**INFRASTRUCTURE
DIRECTORATE**

**ORDINARY
COUNCIL MEETING**

From: "PALANDRI Lou (PMD)" <lou.palandri@mainroads.wa.gov.au>
Date: 20 April 2021 at 10:28:42 am AWST
To: Luke Botica <Luke.Botica@dardanup.wa.gov.au>
Cc: "COPPEN Matthew (PMD/A)" <matthew.coppen@mainroads.wa.gov.au>
Subject: Eaton Drive Proposed Intersection Treatments

Comments on the proposed intersection treatments along Eaton Drive are as follows.

1511 Marmion Ave
Burns Beach, Western Australia
Google
Street View

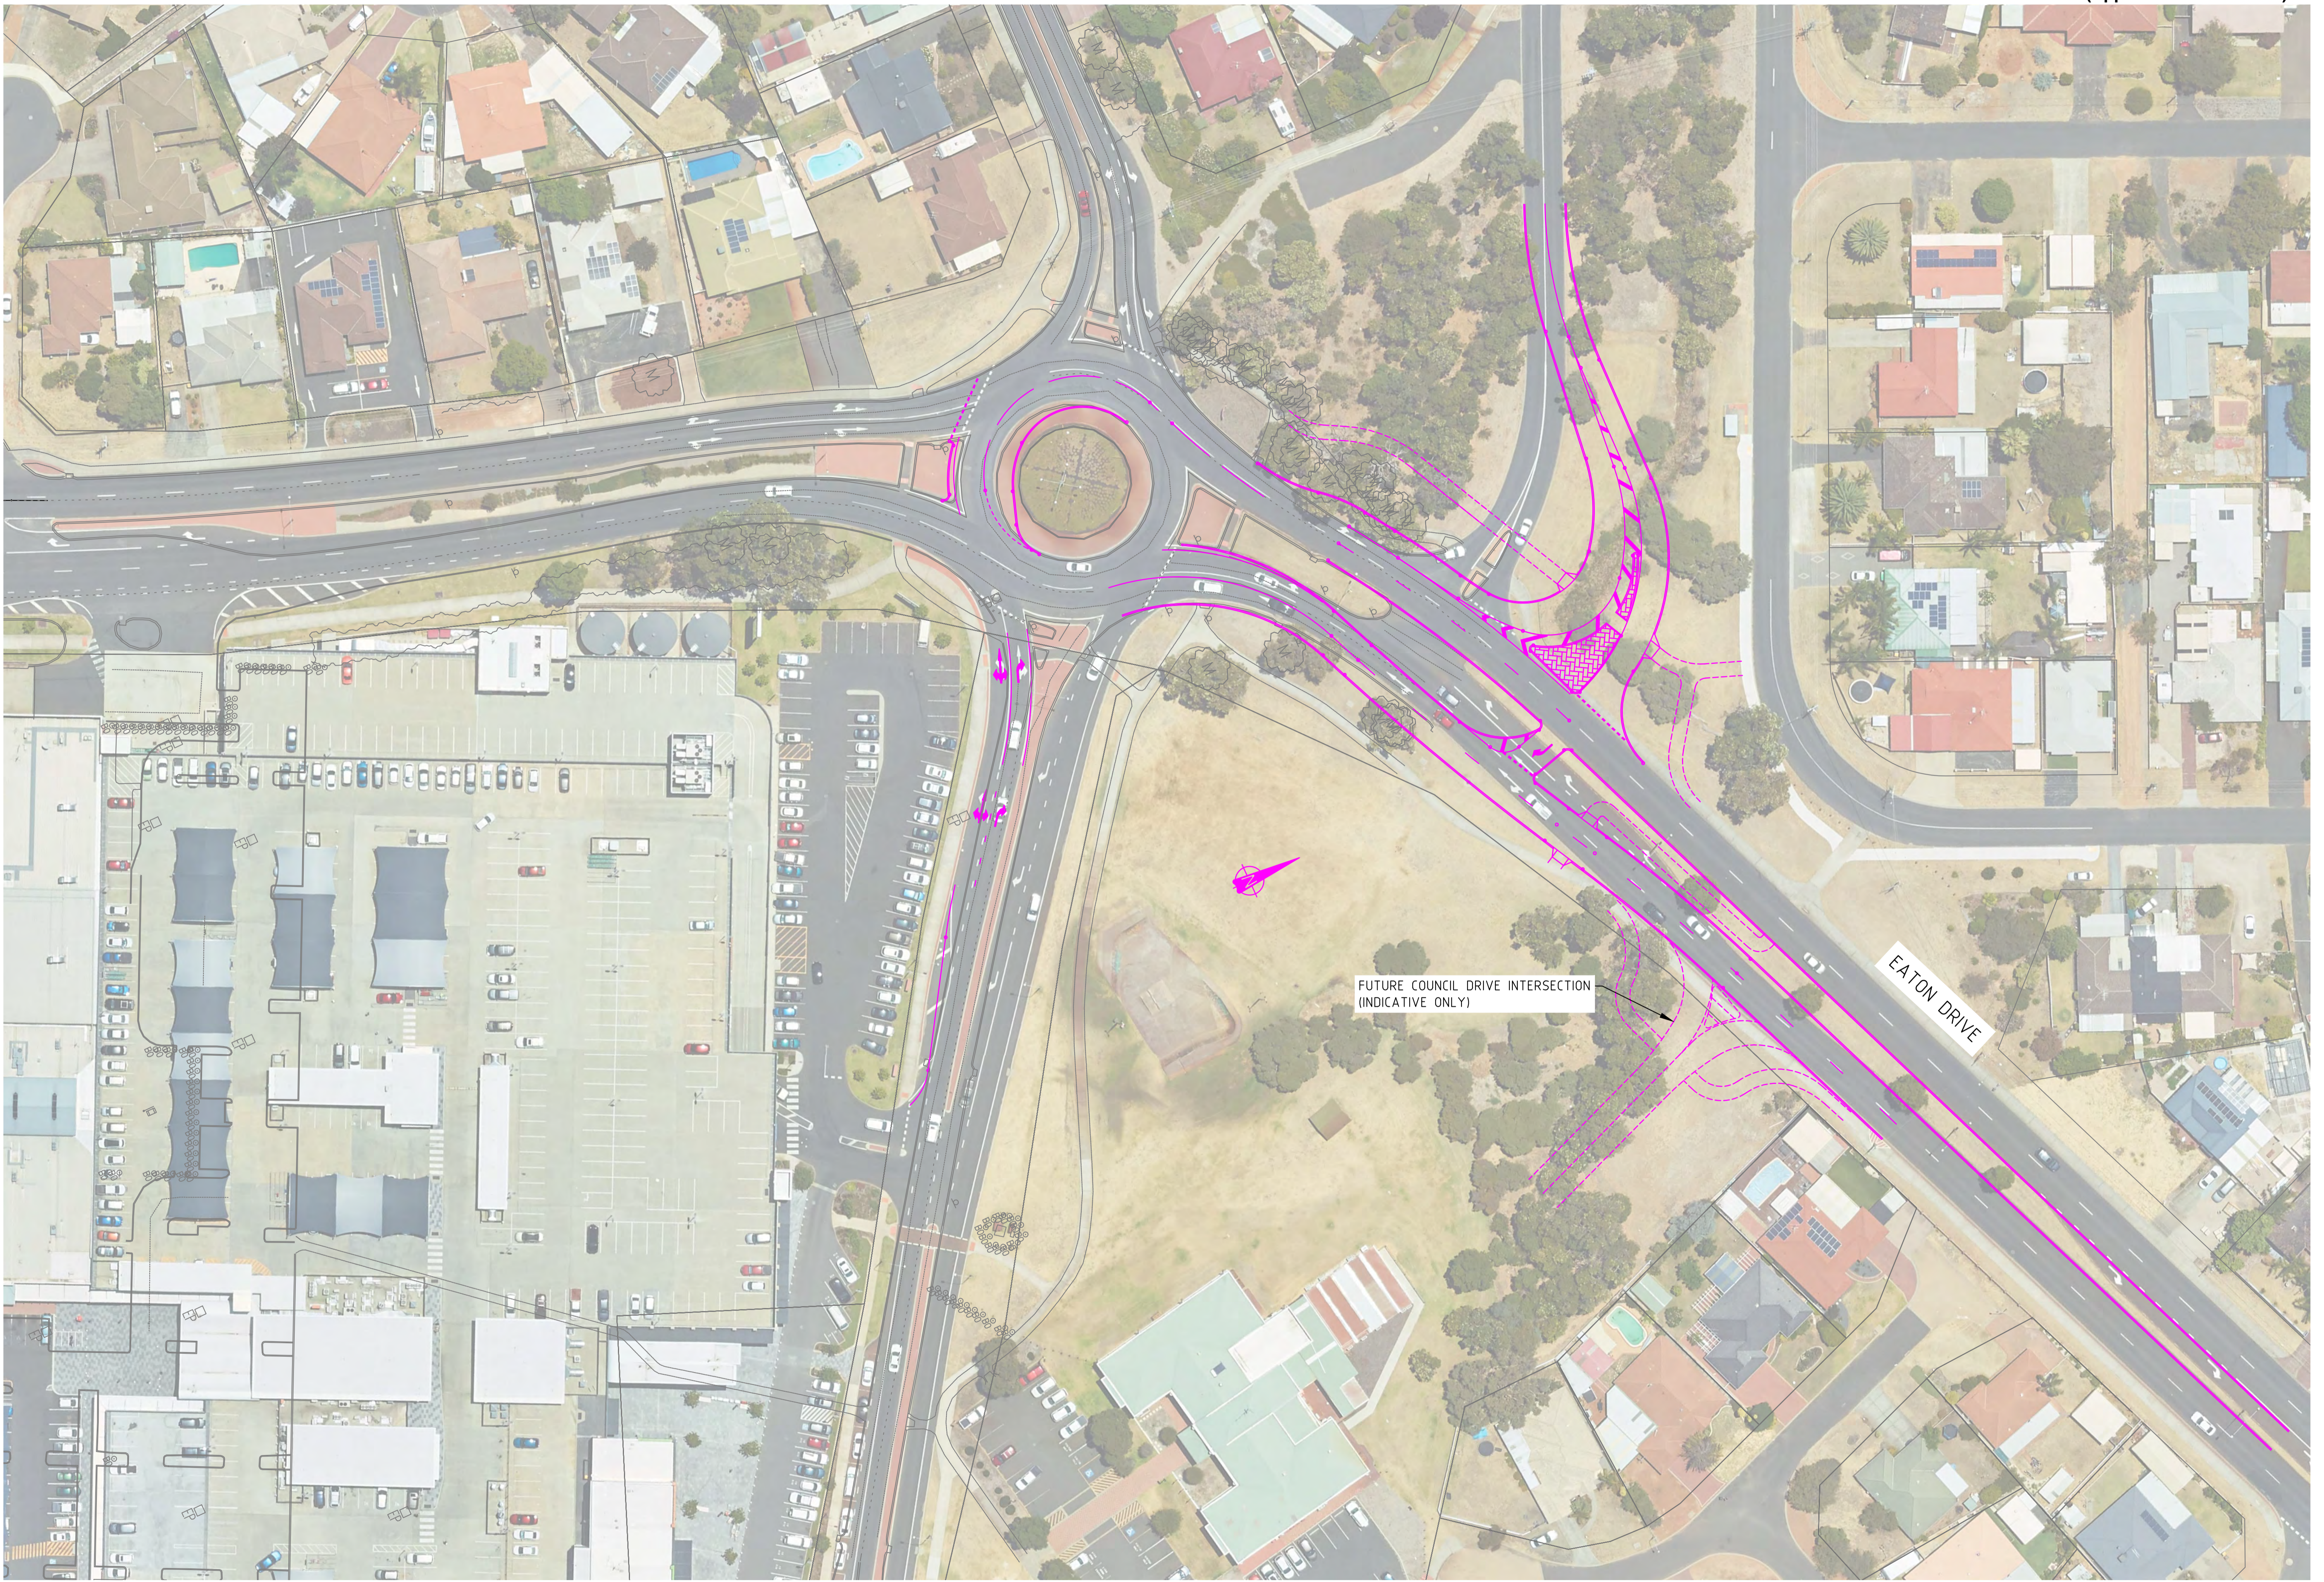
Note that it may also be possible to have the pedestrian crossing of Eaton Drive shown on the plan as a signalised crossing. Attached is a photo of a signalised pedestrian crossing recently installed near a major roundabout on Marmion Avenue in Kinross which shows how the staggered crossing shown on the plan could be signalised.

Watson Reserve Master Plan - Overview
SITE A1

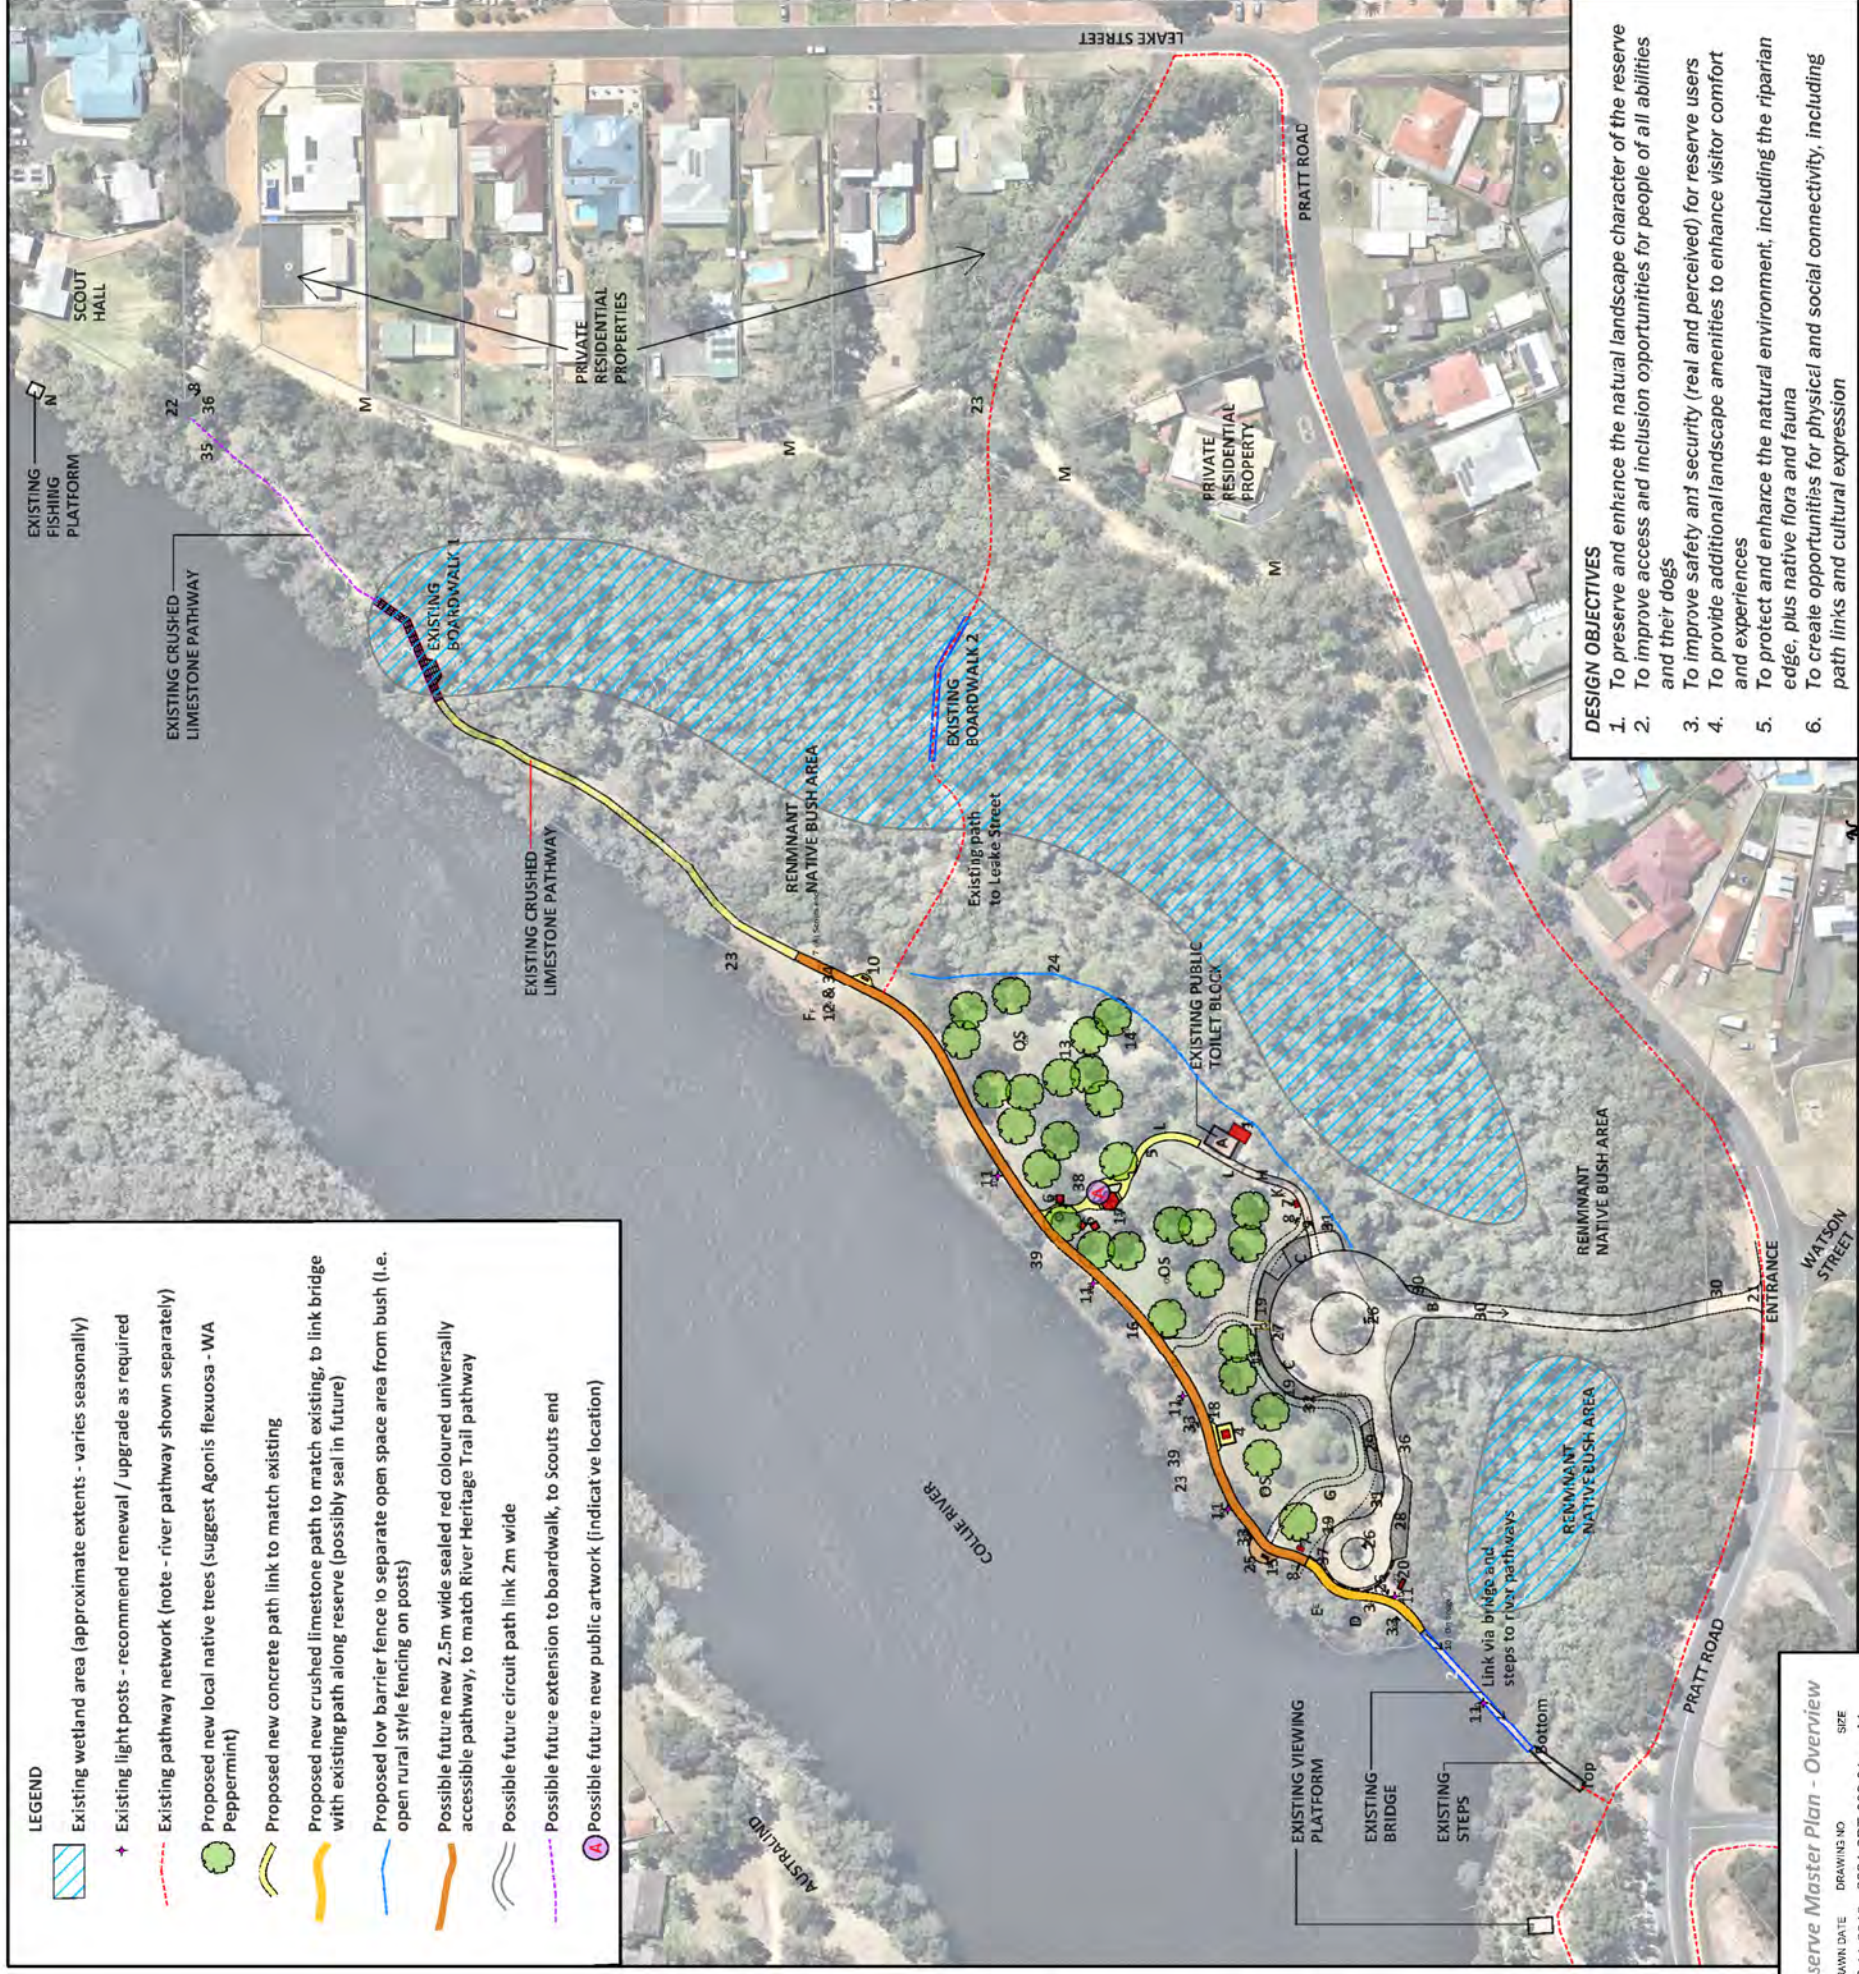
Respondent	Respondent Comment	Officer Comment
Community members:		
1. Mr G.	<p>I regularly use Watson Park Reserve for my dog. I like it the way it is and only really needs a few minor things that look like they're going to happen anyway.</p> <p>The only other thing I suggest is another gazebo at the bridge end of the grassed area. It'd be great especially in winter time.</p> <p>Oh and maybe a few more benches to sit on along the side of the river.</p>	<p>Noted.</p> <p>Additional shelter has been proposed for near the bridge end of the reserve.</p> <p>Additional seating has been proposed in the reserve and along the path.</p>

2. Ms G.	<p>I have perused the draft concept plan for Watsons Reserve and have a few queries and suggestions, which I will list below.</p> <p>Regarding 7 (&19) Signage - what will "shared "use" statement be? Will it reference "leash free area" and the need for dog owners to CONTROL their dogs?</p> <p>I regularly walk the trails along the Collie River and find that many dog owners are apparently oblivious to their dogs' whereabouts and actions, and most often do NOT call their dogs away from certain situations.</p> <p>Will there be upgraded signage at the top of the driveway? Will it reference the shared use driveway, can it have a 'speed limit'?</p> <p>And can dog exercise sign also state that owners MUST still control their dogs? Many other parks in the region do have signs stating this.</p> <p>12. (not numbered) Tree planting - Why is the proposal for</p>	<p>Any proposed signage relating to the reserve's use as an off leash dog exercise area will aim to be 'friendly' in style and reinforce the requirement for dog owners to be in control of their dogs at all times, in accordance with the relevant Local Laws.</p> <p>NB: Response to submitter's questions sent 6/3/2019</p> <p>Noted.</p> <p>Upgraded signage can be considered for the top of the driveway. This – including the request for mention of a speed limit – will be raised with the engineering design team who look after the Shire's roads.</p> <p>Yes, this is intended.</p> <p>Agonis flexuosa has been nominated as a focus tree species</p>

3.	<p>Ms F. First I hope no trees are going to be removed at all for this work to be done along the river flats. Their age and size are beautiful. It looks like the car park is planted on the peppermint tree alongside the existing path. Don't take this out! Second, where is the board walk in the design. It is an important part of this area that needs to remain as it is used often.</p>	<p>It is not proposed to remove any existing trees unless there are any identified down the track to be hazardous to public safety. The car parking shown on the plan is indicative only and shown as 'subject to detailed design' – through which every effort will be made to work around existing healthy trees, ensuring that they are retained and protected. A brief note to this effect can be included on the revised plan. The advertised draft plan focused primarily on the main open space area of Watson Reserve which is why the boardwalks did not appear on the original draft plan. The plan can be amended to show the boardwalks. They are valued by many reserve users and an important part of the pathway access system through the reserve so it is intended for them to be retained and improved as required and as funds allow.</p>

4.	<p>Ms R. The draft plan looks really good although I am still concerned about the addition of a "good shade shelter with accessible picnic setting" as this apparently has to be a shared-use area. I am hoping that people who do not have a dog will prefer to use the Foreshore park..... although I think the shade shelter and picnic setting may encourage people to go to Watson's Reserve for that reason. I say this because having spoken to a number of regular dog owners who use the park, people without dogs can sometimes be very confronting.</p>	<p>The proposal for a new picnic shelter and setting near the popular fishing spot and proposed river platform may help to provide an 'off the ground' picnic and general seating opportunity, as it is understood from comments received that misunderstandings can occur when dogs rush over and jump on people who might be sitting on the ground having a picnic. A raised table may help to reduce the incidence of such a situation occurring. The proposed picnic shelter has been intentionally located at the other side of the park to where the dog exercise group generally tends to gather, to</p>

5. Mr B.	<p>There is no plan to fix up the waters' edge and get rid of the ugly boulders.</p> <p>This was once a great family area for kids to swim in the river and even had a rope swing to swing out into the water. If a limestone wall was to be built to protect the river bank and some steps to get into the water it would enhance the use by the greater public.</p>	<p>The Shire is presently working with adjoining Local Government areas and the Department of Water and Environmental Regulation on the Lower Collicie River Master Plan project, which is considering erosion mitigation and water quality along and in the river. The objective of this project is to plan a comprehensive solution across the whole of the river, and as working in one area will affect all other parts of the river it will be done with a strategic plan in place. Watson Reserve is being considered within the overall context of this project and it is advisable to wait until an overall strategy for the river is in place prior to undertaking significant localised erosion control works. The Director of Infrastructure has confirmed that the plans can be updated to include the recommended treatments which could also include some sections of limestone wall or other retaining wall (e.g. sheet piles etc).</p>

<p>Has there been a fire strategy produced for this area due to only one exit by vehicle and three by foot going through the fire fuel area.</p>	<p>A dedicated fire strategy has not yet been prepared for the Reserve however the Shire's Bushfire Risk Planning Coordinator was consulted in 2018 and provided advice with respect to bushfire considerations. The main recommendation was to ensure that the firebreaks between the Reserve and adjoining private properties be maintained, which is an important operational consideration. It is intended to retain and protect the existing wetland for environmental reasons and in line with the consultation outcome of 'keeping the reserve as natural as possible' in addition to which the wetland itself could be seen as a fire dampening 'buffer'. In the event of a fire in the bush surrounding the reserve, people may be more likely to head towards the river rather than through the access driveway and paths.</p>
